Engineering Change Notice	Model Name :	Date	June 23, 2009
		REV	1

Engineering Change Notice

T-51991GD015-MLW-AIN

OPTREX CORPORATION PM Division

2. Review for the Modification

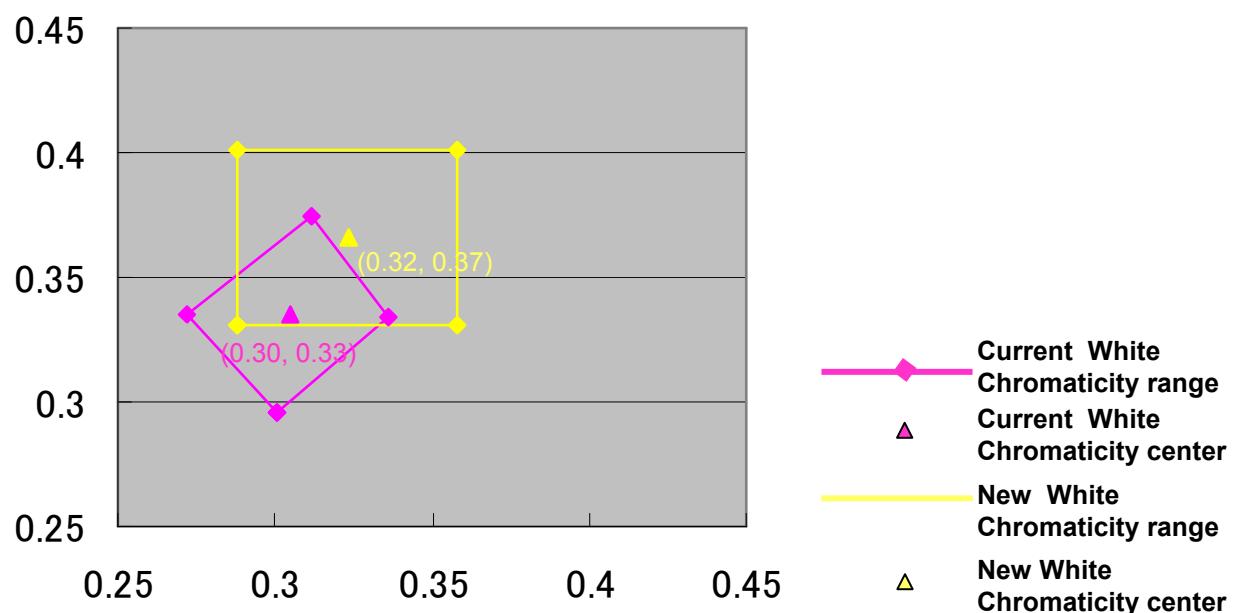
Items	Comment for difference
Viewing angle range	No change at New Product.
Contrast Ratio (Backlight On)	No change at New Product
Brightness (Backlight On)	No change at New Product
Brightness uniformity (Backlight On)	No change at New Product
Color Chromaticity (Backlight On)	See the next page.
Driving condition for Backlight	No change at New Product Forward voltage 6.4V(Typ) (@ IF = 20mA)
FPC	The color was changed.
